Public Comments

9/6/2023

RE: Northgate Town Square Design Review

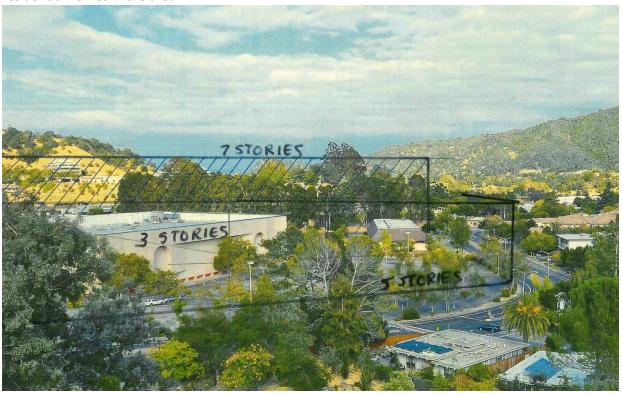
Looking down on the mall from Quail Hill Townhomes is very sobering given the extraordinary proposed 5 - 7 story structures. According to the laws of perspective, I hand drew the implications of these overly-tall buildings on the site. I do not have all the setbacks etc. so it is not completely accurate. However, it does show how the structures (which more appropriately should be built closer to the freeway entrance on the northwest corner adjacent to an existing 5 story commercial building) are MASSIVE, dwarfing residential homes in the area.

When you consider that the perspective shown is <u>looking down</u> on the buildings, you can only imagine how dwarfed a person is relative to these proposed structures. (for scale, see white car parked near the old Sears building)

Thank you for your consideration in <u>not approving the excessive heights of the buildings and to relocate</u> them to the more appropriate northwest corner of the property.
